ADDENDUM NO. 2

CLARIFICATION NO. 2

LANDSCOPE (MAURITIUS) LTD
INFRASTRUCTURE WORKS FOR EDUCATION AND HEALTH HUB AT COTE D'OR
REF No.: LM/CD/OC23/35

Drawing number
23125-TD-2TP662

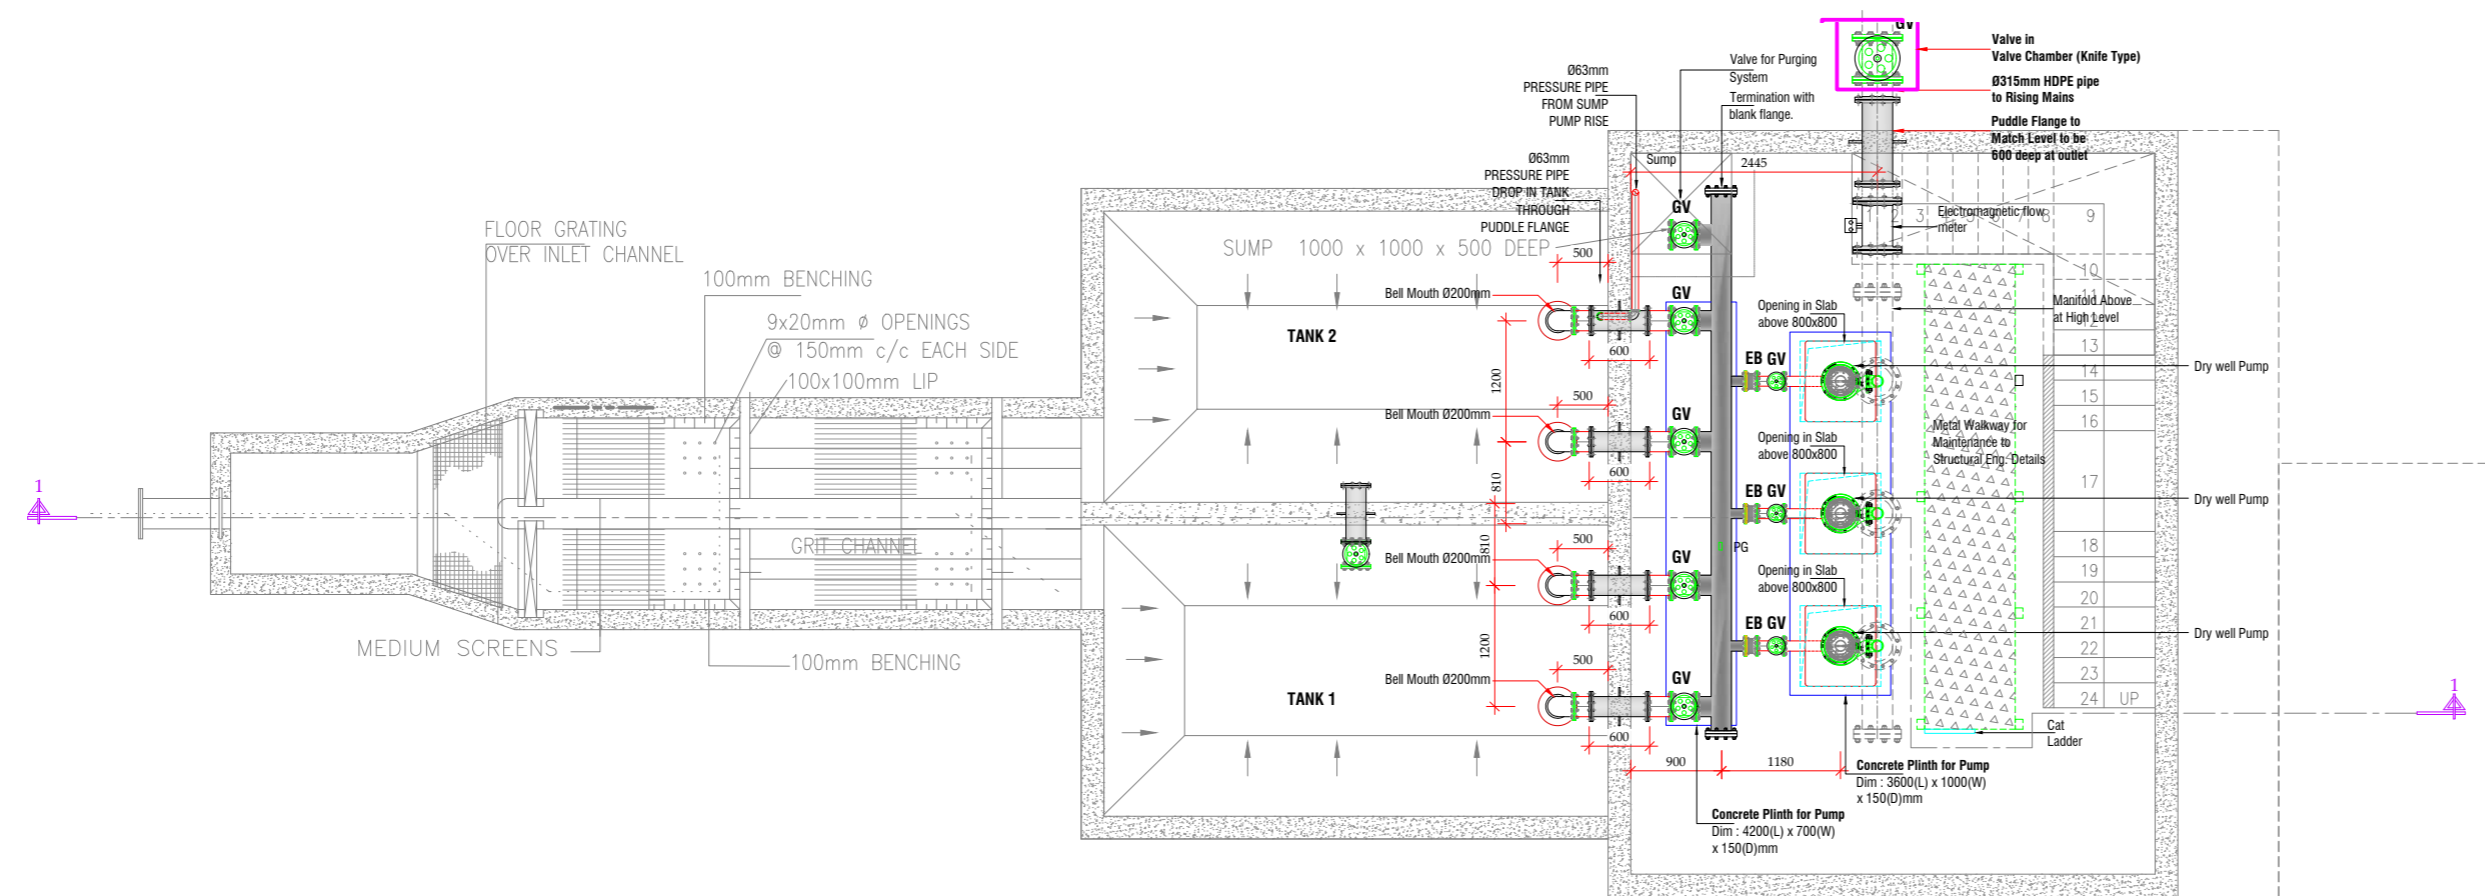
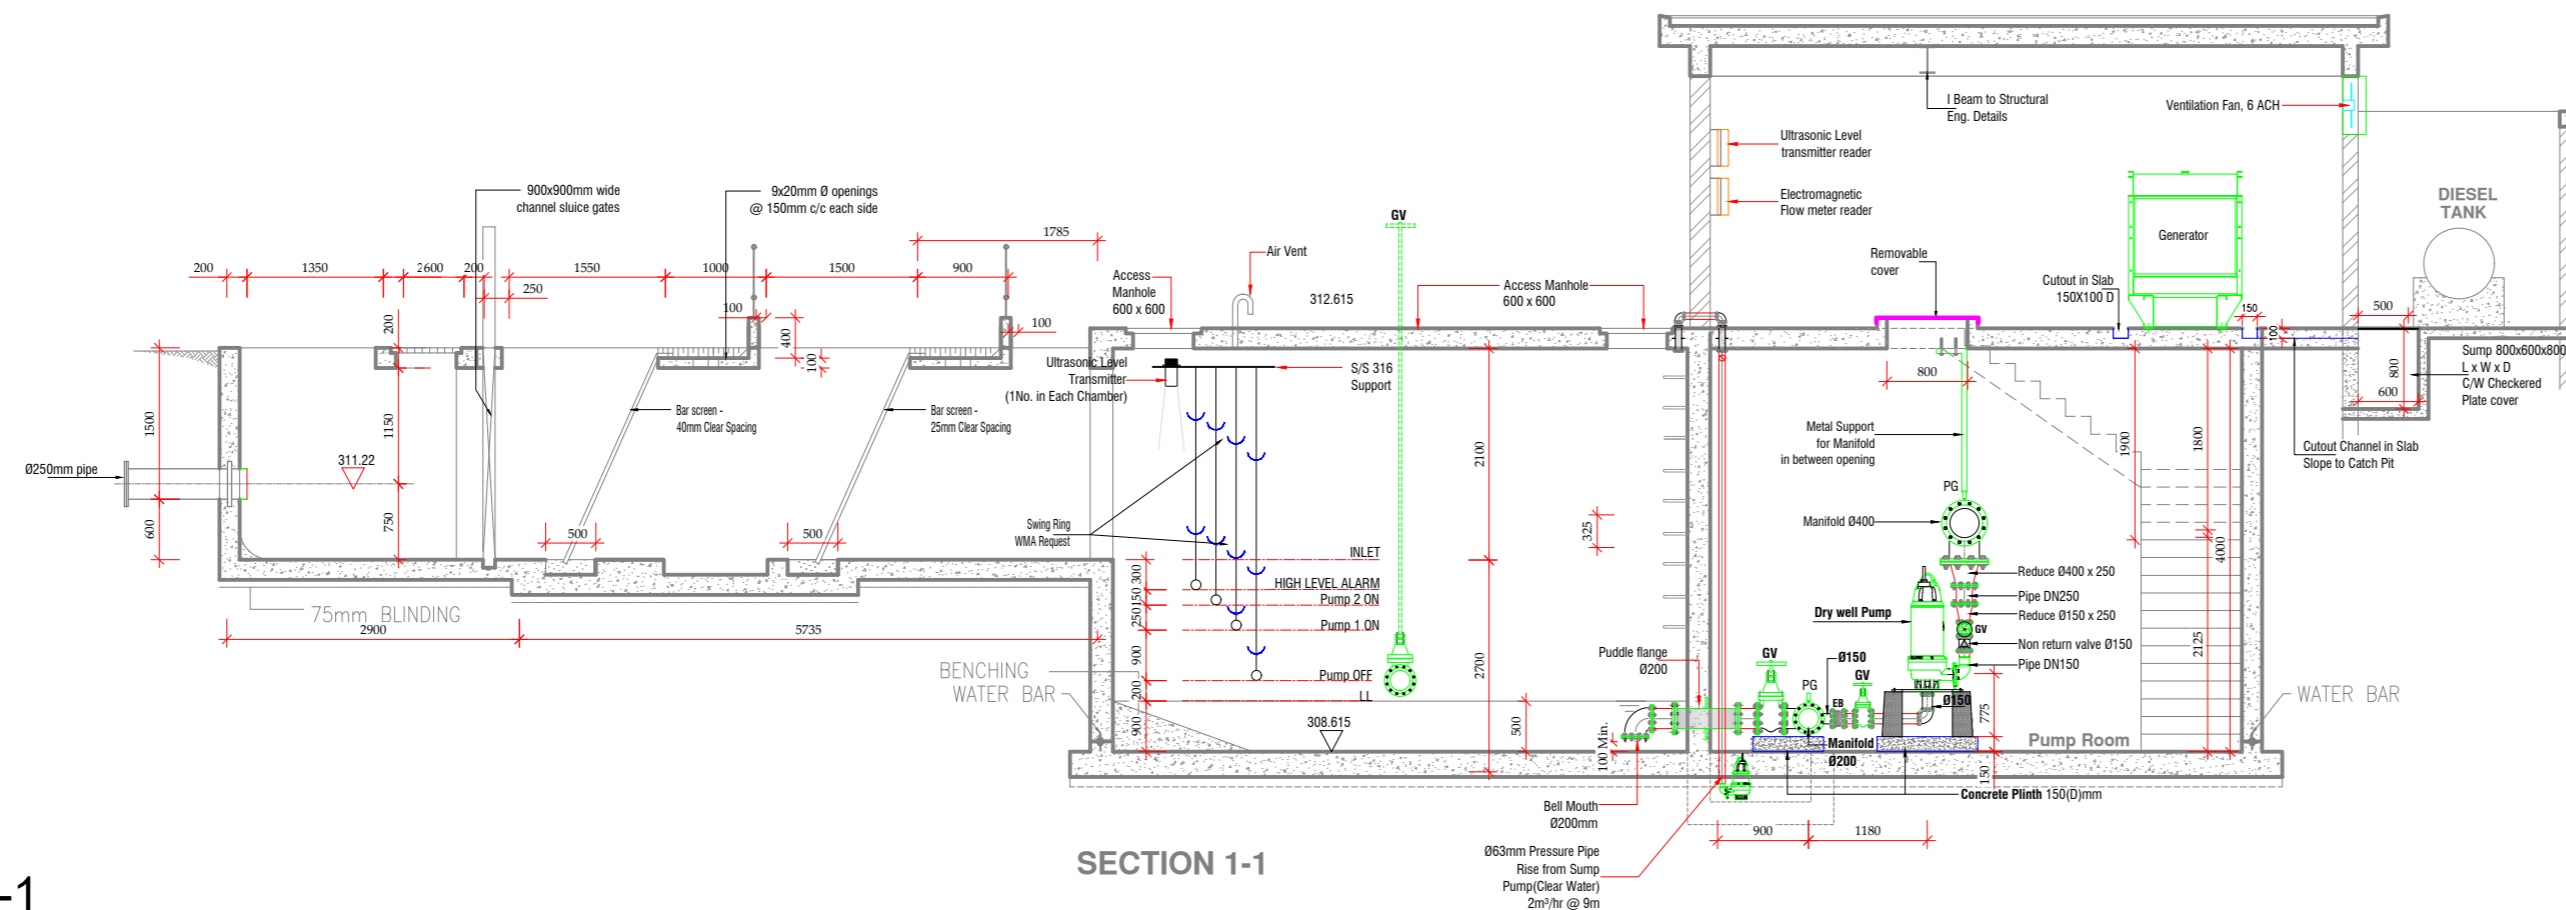
19.	Lot 1 Bill Item 1213B & 1213C Provide detailed drawing with dimensions	The bidder shall quote as specified in the bill description. It is hereby brought to the attention of the bidders that 23125-TD-2TP662 of Volume 3 of 4 has been replaced by 23125-TD-2TP662 marked as “Addendum No. 2” in which the location of the screens is shown. Same is attached in Annex G

23125-TD-3TP219

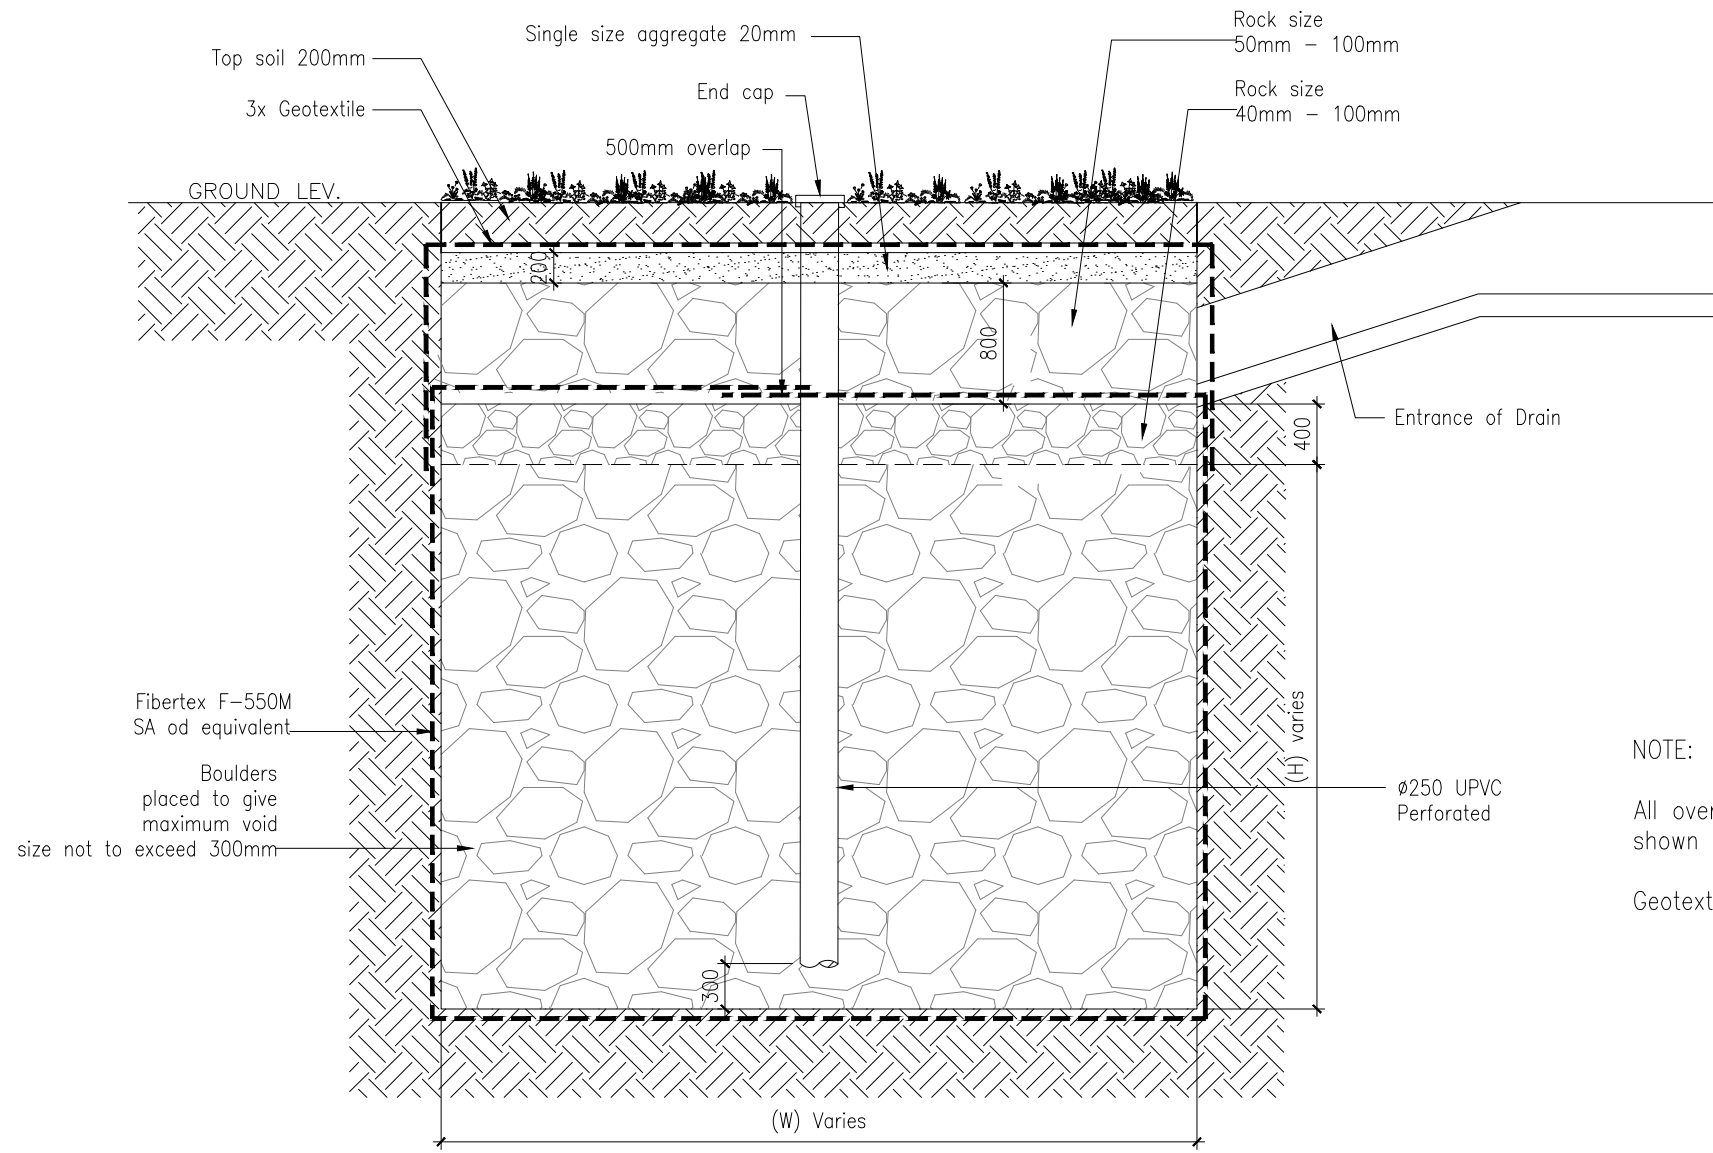
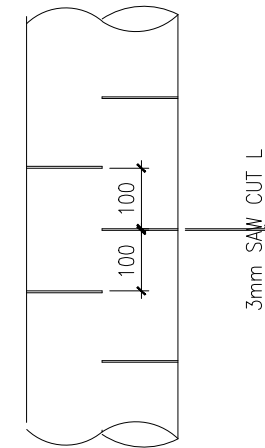
23.	Lot 1 Bill Item 1310F Provide detailed drawing with dimensions.	It is hereby brought to the attention of the bidders that a new drawing labelled 23125-TD-3TP219 marked with “Addendum No. 2” forms part of Volume 3 of 4 the bidding document as attached in Annex J .

Drawing number
23125-TD-1BR02
 File name and location no.
 C:\USERS\VG\APPDATA\LOCAL\MICROSOFT\WINDOWS\NETCACHE\CONTENT\23125-TD-1BR02.DWG
 ©COPYRIGHT RESERVED

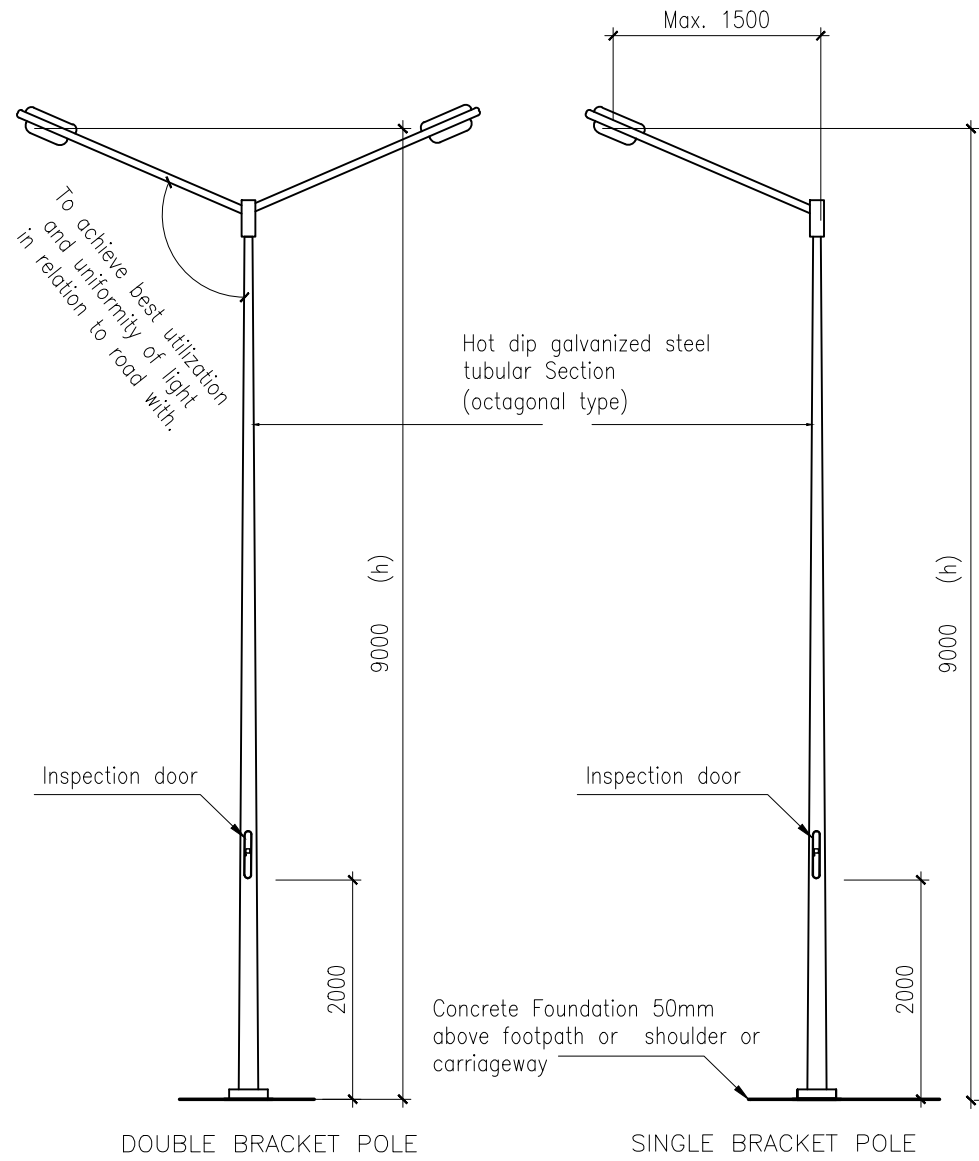
29.	Lot 1 Bill Item 1405D Kindly provide detailed drawing with dimensions	It is hereby brought to the attention of bidders that 23125-TD-1BR02 of Volume 3 of 4 has been replaced by 23125-TD-1BR02 marked as “Addendum No.2” as attached in Annex M .

Drawing number: 23125-TD-3TP500.
Stage: TENDER
File name and location no. D:\EDUCATION HUB\Addendum\Addendum No. 3\Updated drawings\Typical\23125-TD-3TP500.dwg

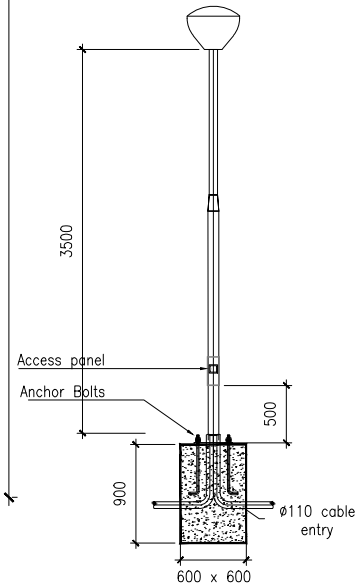
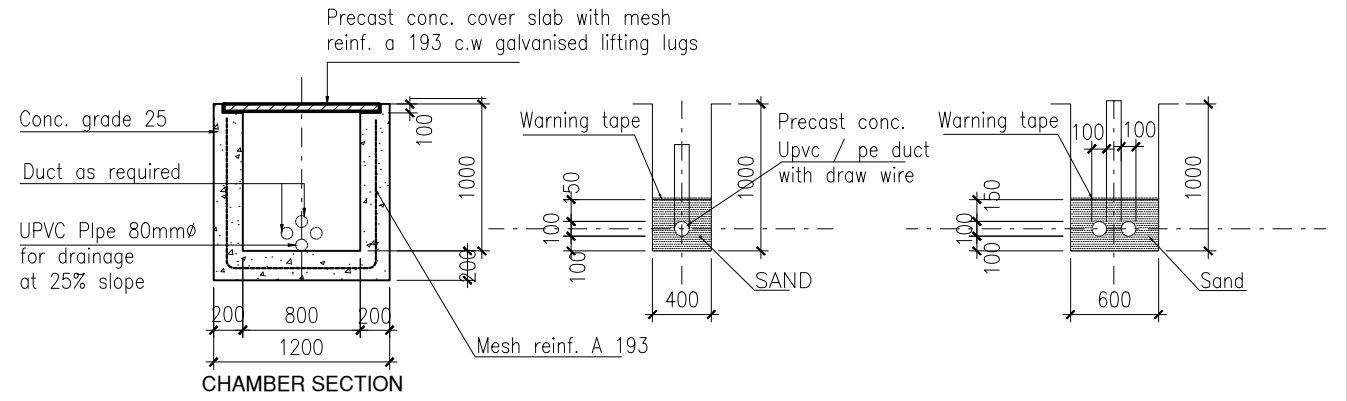
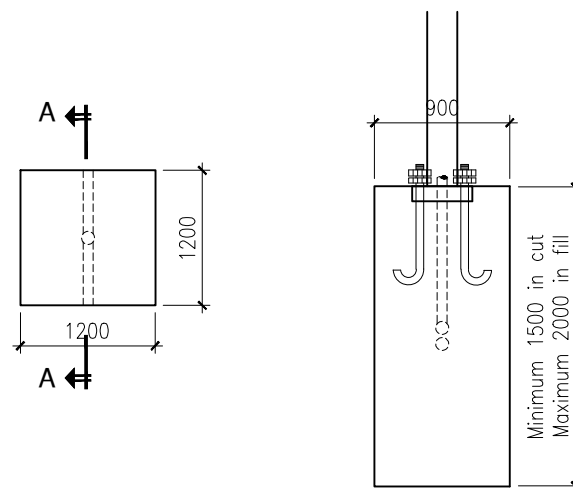
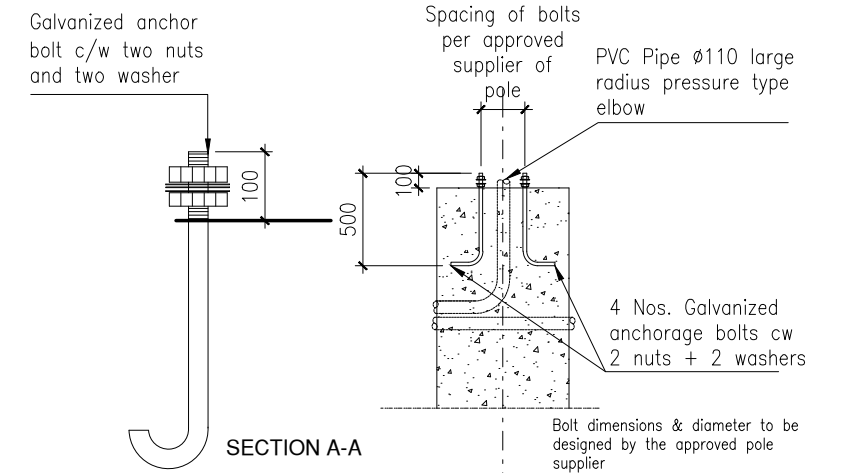
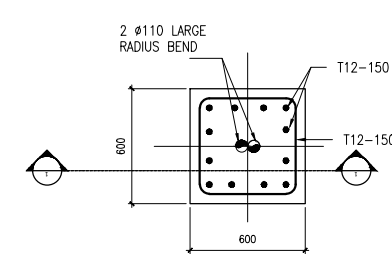
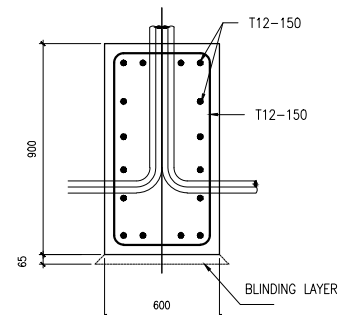
31.	Lot 2 Bill Item 707D Please provide column foundation details for the 3.5m high pole	It is hereby brought to the attention of bidders that 23125-TD-3TP500 of Volume 3 of 4 has been replaced by 23125-TD-3TP500 marked as “Addendum No. 2” as attached in Annex N .
